IN-FLIGHT ICING ENCOUNTER AND LOSS OF CONTROL
SIMMONS AIRLINES, d.b.a. AMERICAN EAGLE FLIGHT 4184
AVIONS de TRANSPORT REGIONAL (ATR)
MODEL 72-212, N401AM
ROSELAWN, INDIANA
OCTOBER 31, 1994

VOLUME II: RESPONSE OF BUREAU ENQUETES-ACCIDENTS
TO SAFETY BOARD'S DRAFT REPORT

Abstract: Volume II contains the comments of the Bureau Enquetes-Accidents on the Safety Board's draft of the accident report. The comments are provided in accordance with Annex 13 to the Convention on International Civil Aviation. Volume I of this report explains the crash of American Eagle flight 4184, an ATR 72 airplane during a rapid descent after an uncommanded roll excursion. The safety issues discussed in the report focused on communicating hazardous weather information to flightcrews, Federal regulations on aircraft icing and icing certification requirements, the monitoring of aircraft airworthiness, and flightcrew training for unusual events/attitudes. Safety recommendations concerning these issues were addressed to the Federal Aviation Administration, the National Oceanic and Atmospheric Administration, and AMR Eagle.

COMMENTS OF THE BUREAU ENQUETES ACCIDENTS (FRANCE)

FIGURE 2 : FLIGHT 4184 CVR TIME HISTORY

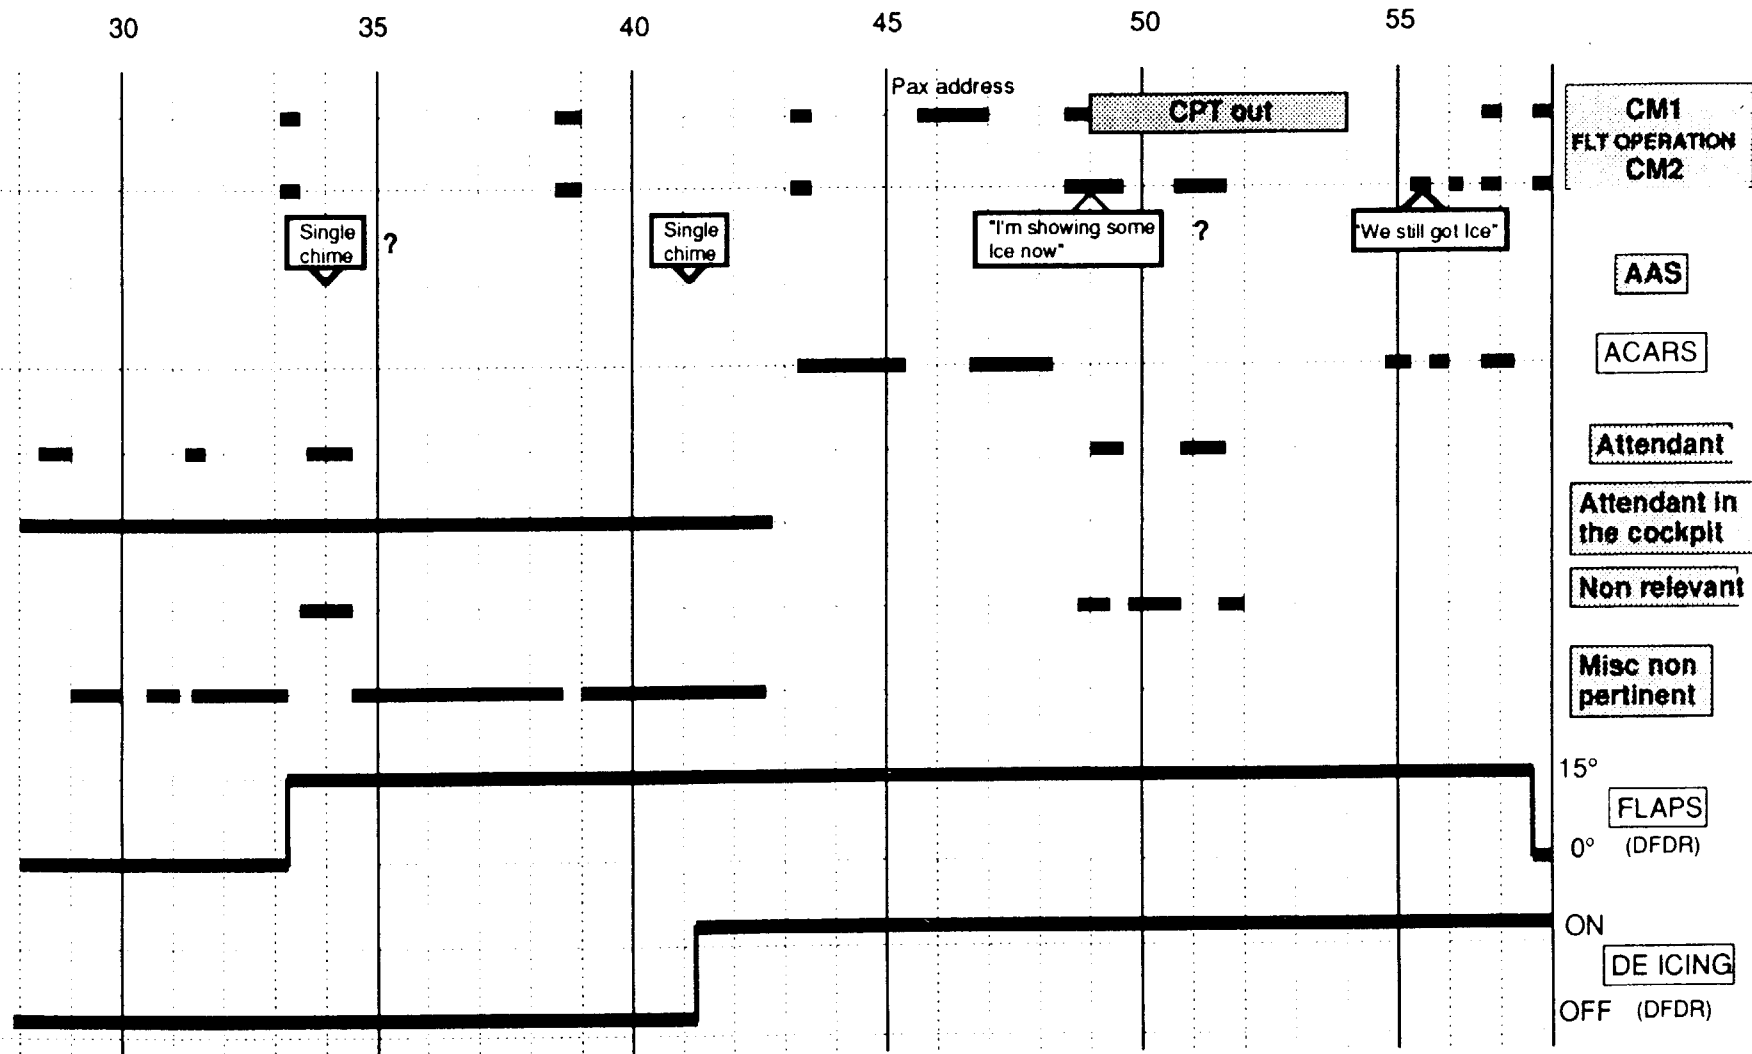
Flight 4184 CVR transcript by NTSB was highly unedited

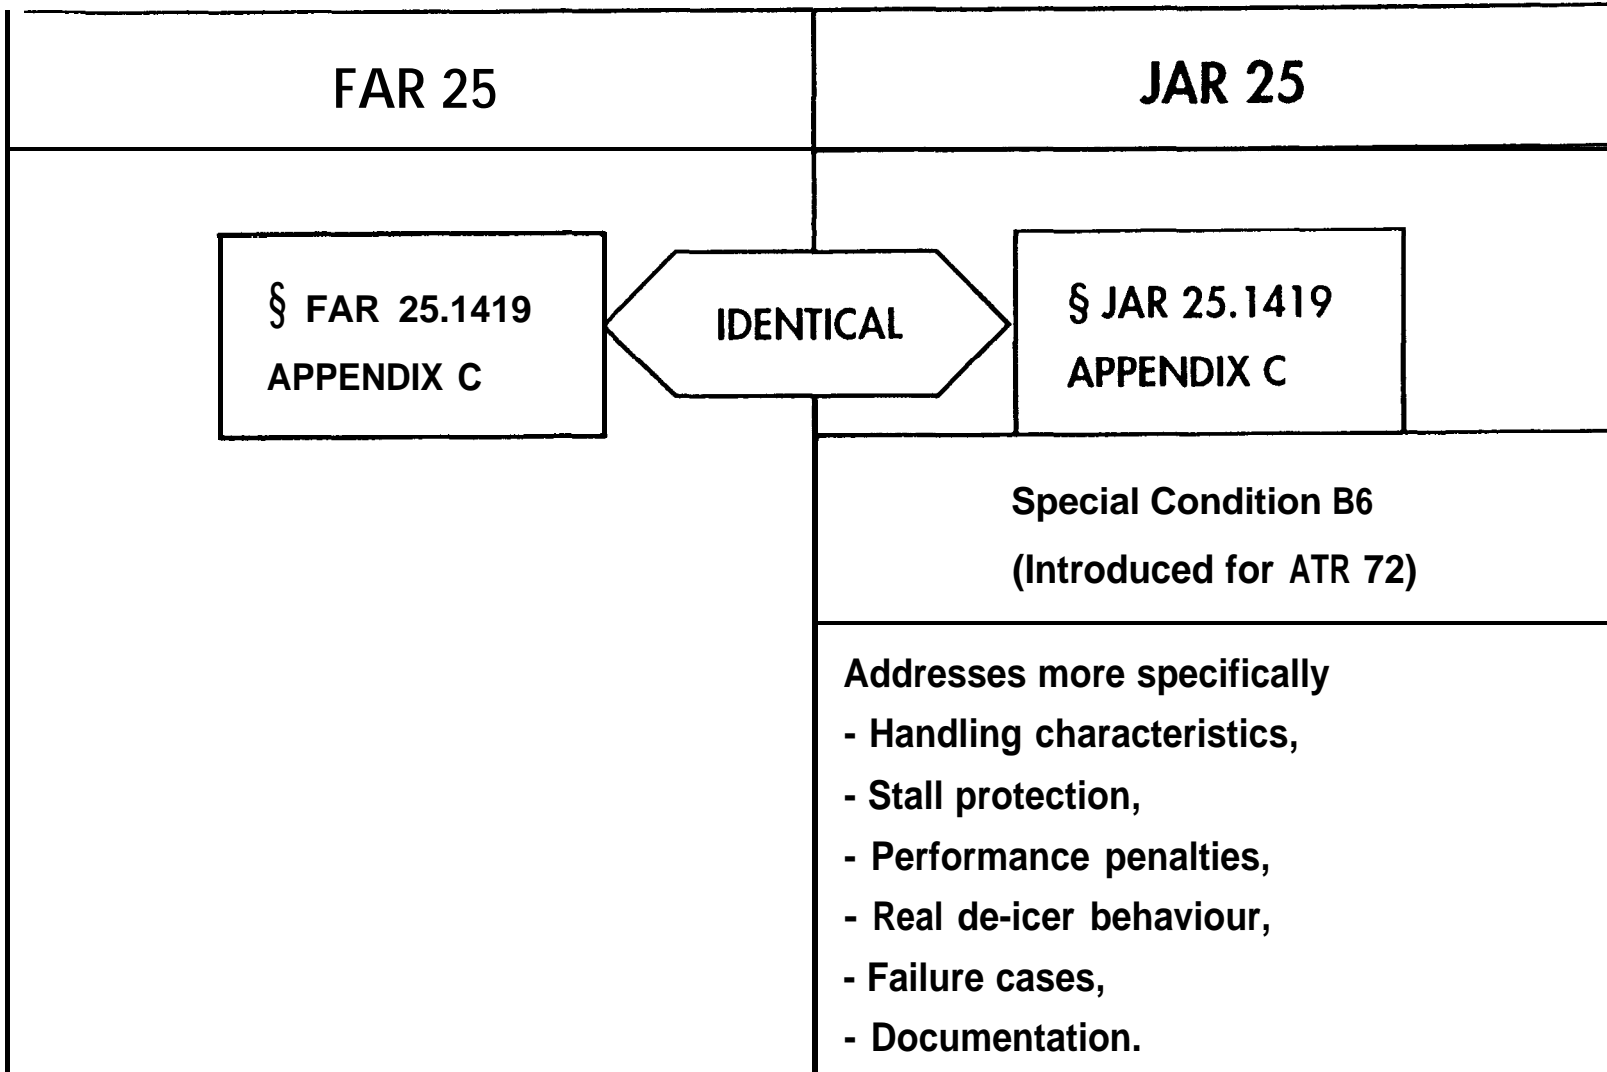
ROSELAWN conditions were far outside App "C" certification envelope

FIGURE 14 : FLIGHT 4184 CVR TIME ANALYSIS

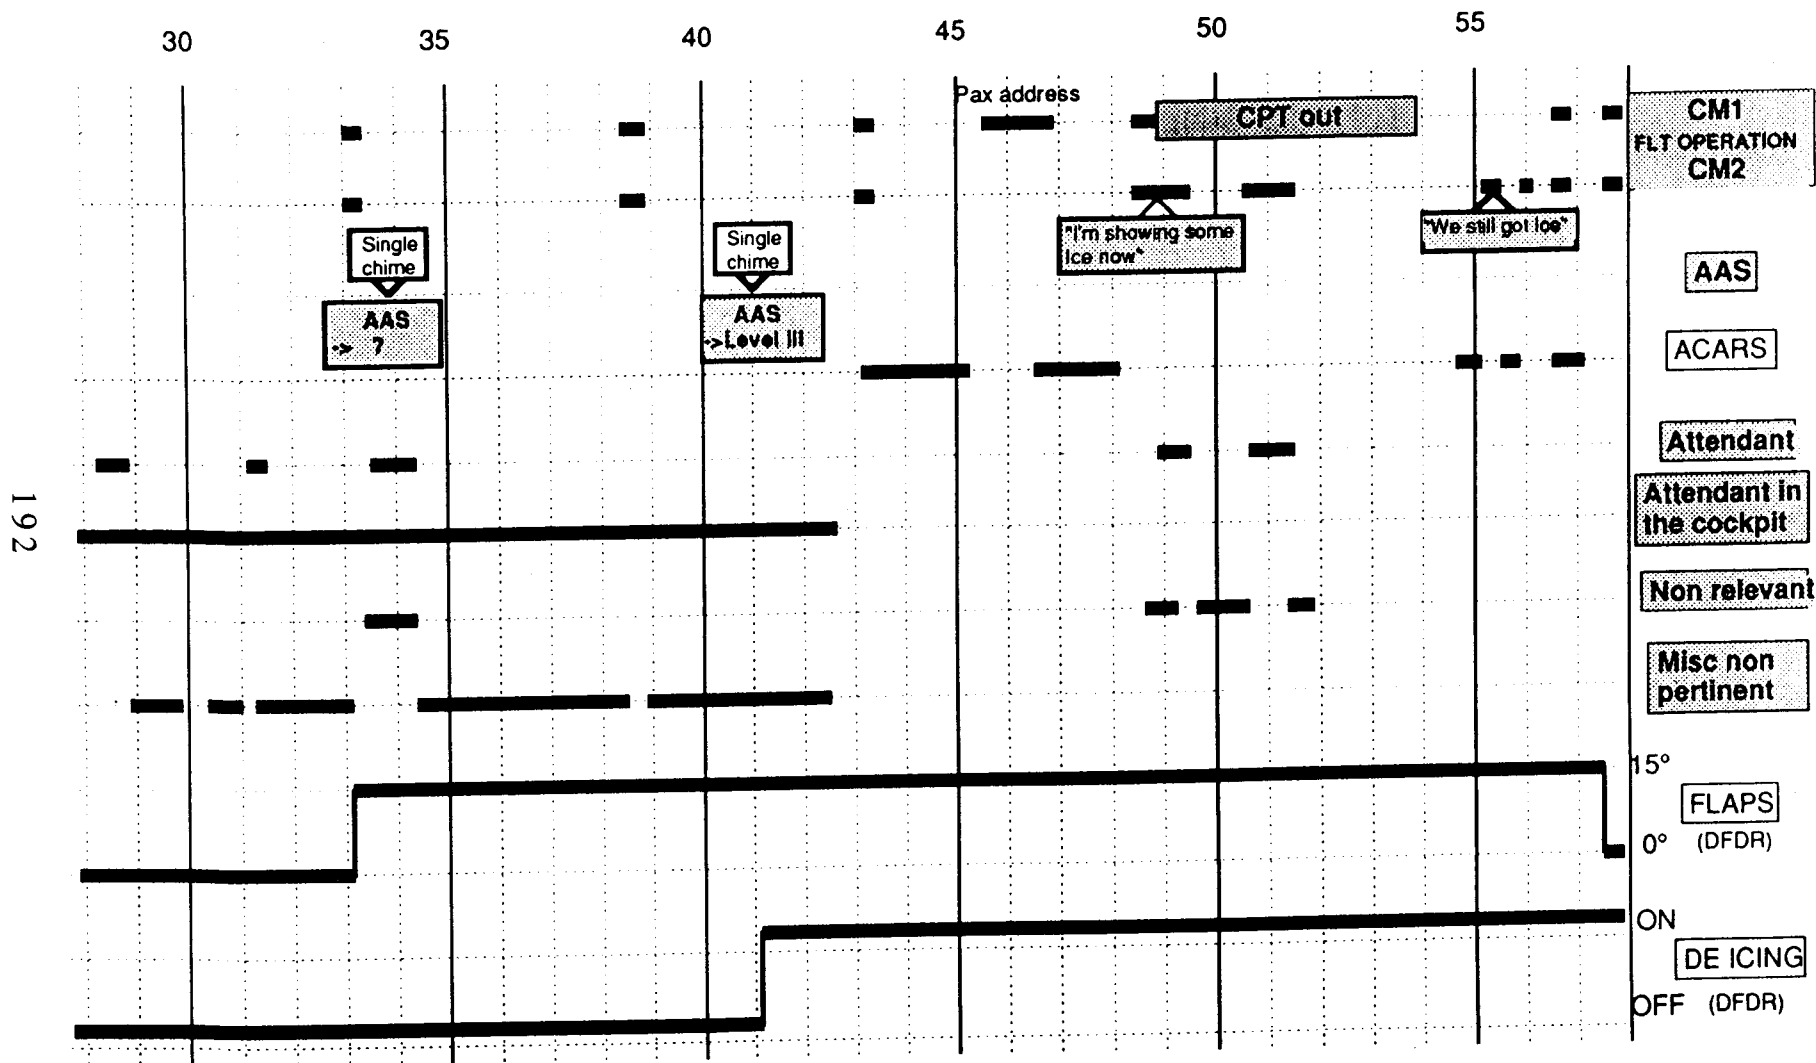
More than 15 mn of Non Relevant & Non Pertinent conversations

FIGURE 19 : RECOVERY CAPABILITY THROUGH CONSTANT ROLL INPUT

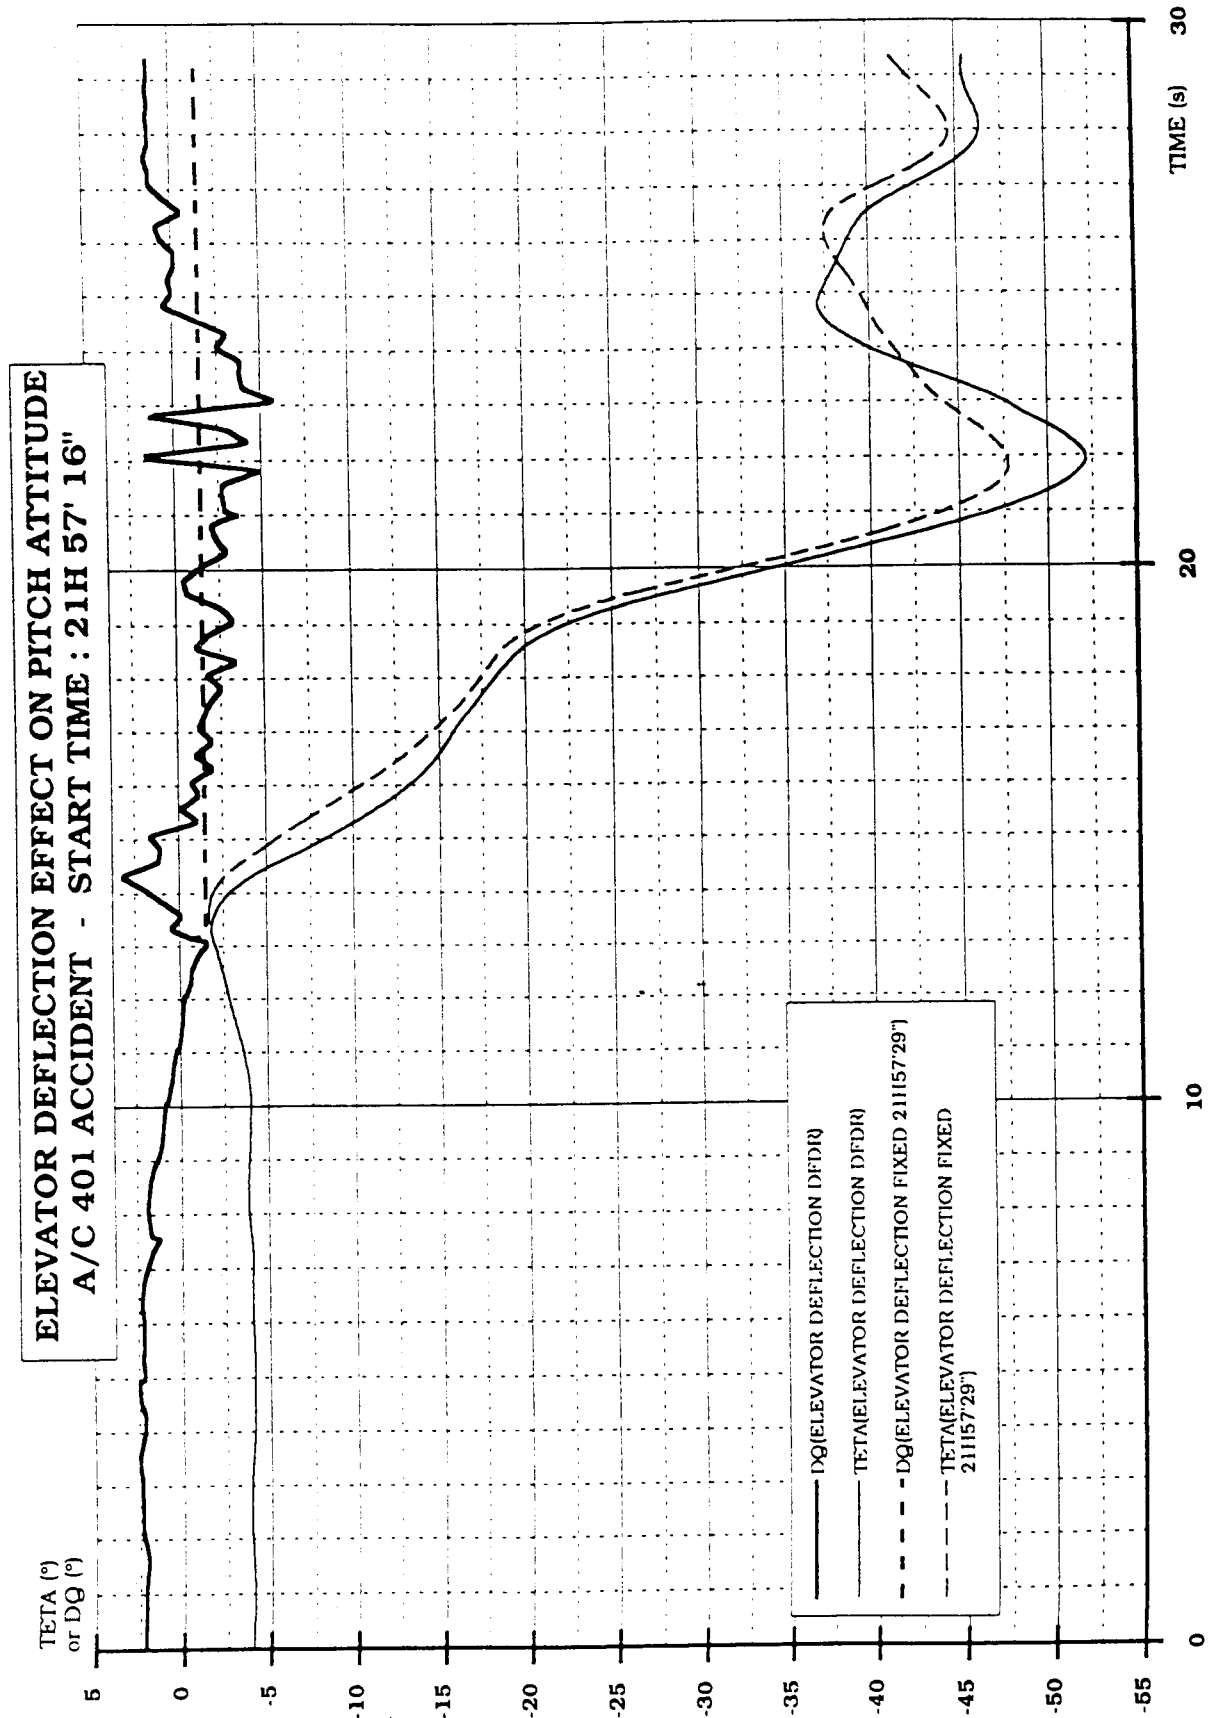
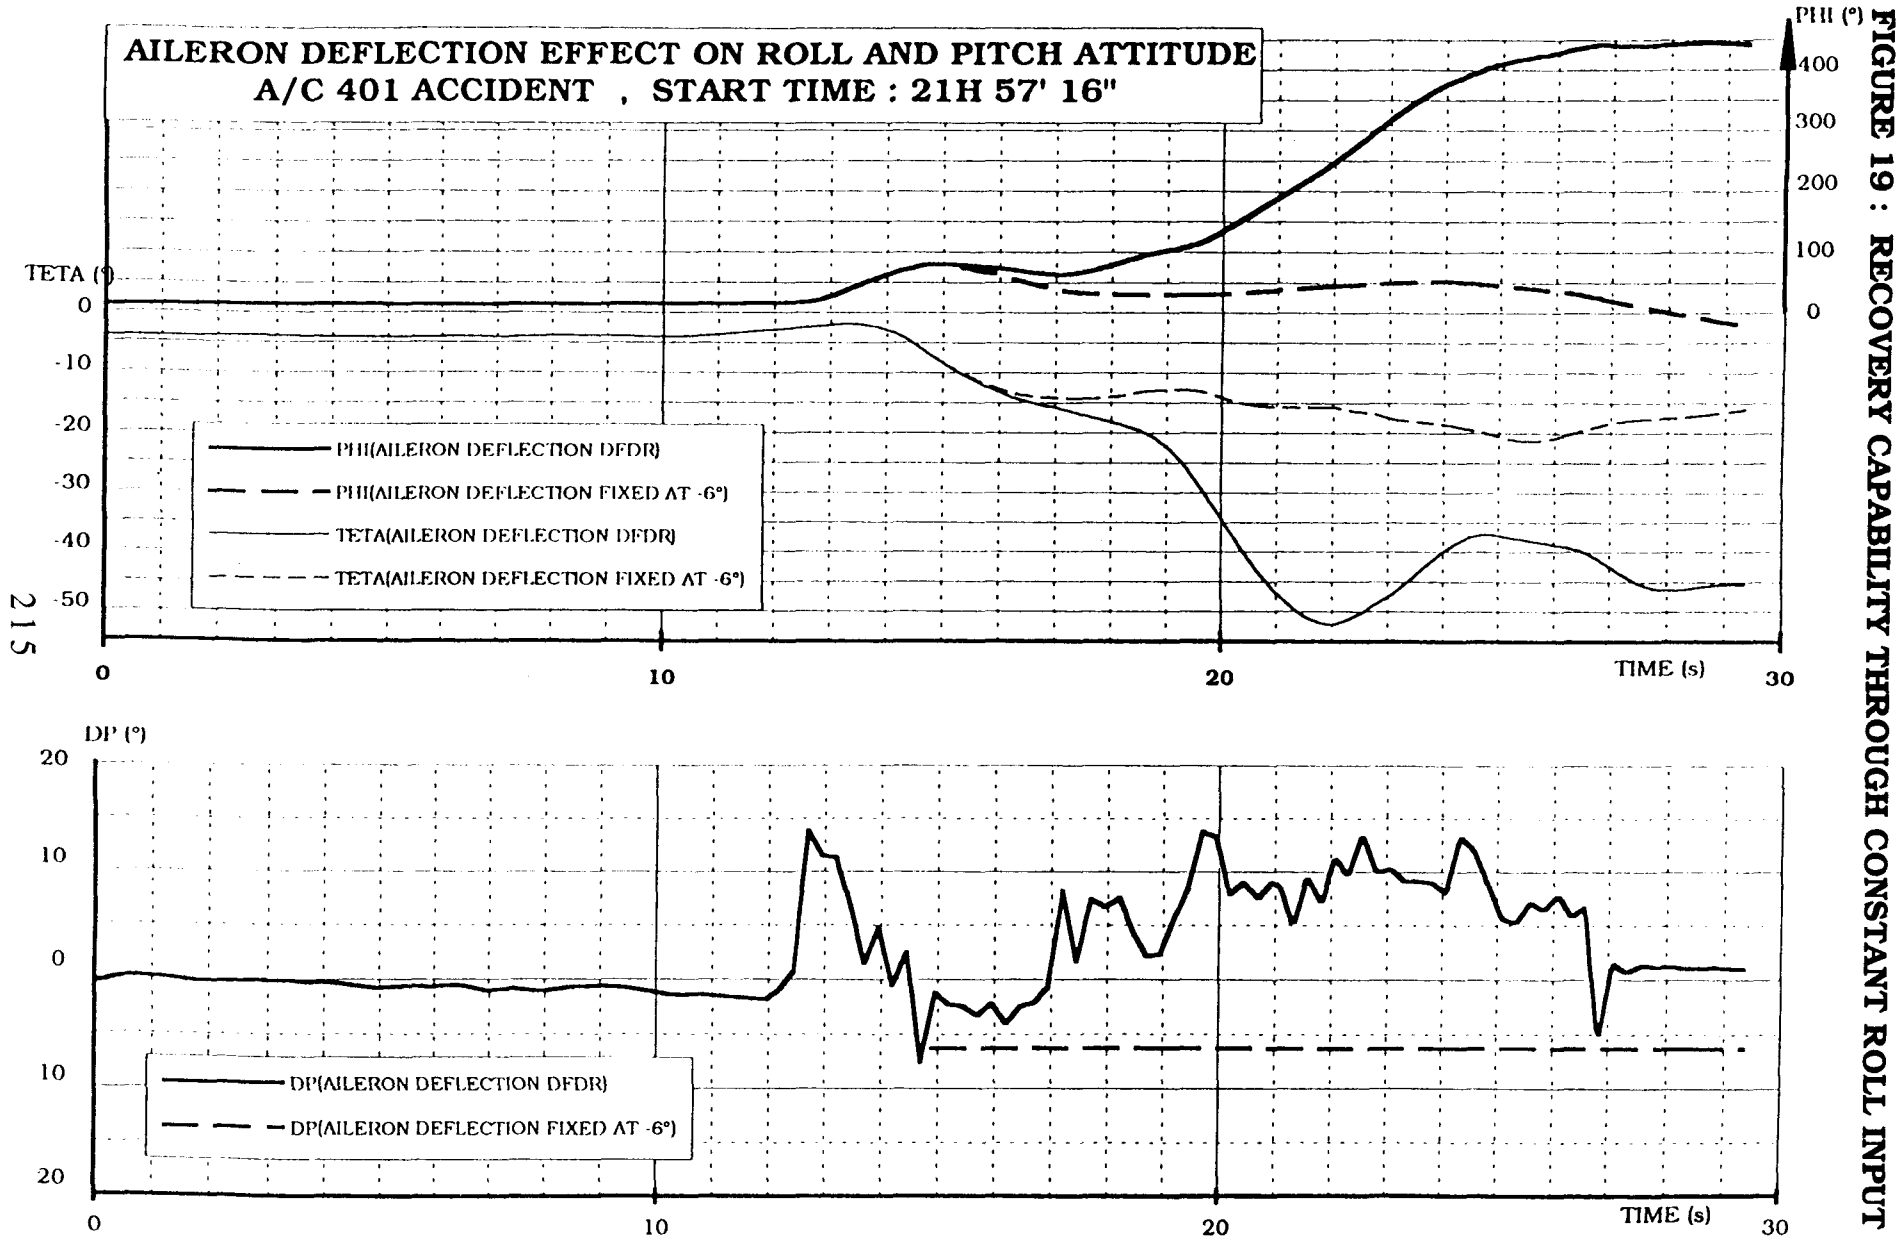
It also allows to predict the Flight path resulting from different control surface deflections. It is thus possible to determine (fig. 18) that the deflection of the elevators contributes only marginally to the longitudinal movement whose amplitude is mainly due to roll initiation.

Moreover, assuming a counteracting steady deflection limited to 6° on the ailerons and applied after the maximum conventional crew reaction time used in cruise (3 seconds) after disconnection, the Flight path is rapidly controlled (fig. 19). The lateral attitude is kept close to wings level and the longitudinal attitude does not exceed 22° before returning to 0° .

A constant 6° roll input after 3 sec would allow for recovery
